# UNITED STATES PATENT AND TRADEMARK OFFICE

10/803,142

<b>Office Action Summary</b>	<b>Application No.</b> 10/803,142	<b>Applicant(s)</b> SUGIURA ET AL.	
	<b>Examiner</b> Daniel J. Colilla	<b>Art Unit</b> 2854

## **DETAILED ACTION**

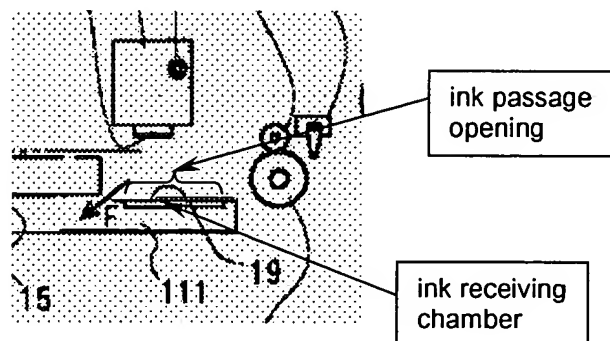
With respect to claim 3, Seshimo discloses an ink passage opening and an ink receiving chamber as shown below in the Figure taken from Figure 6 of Seshimo:
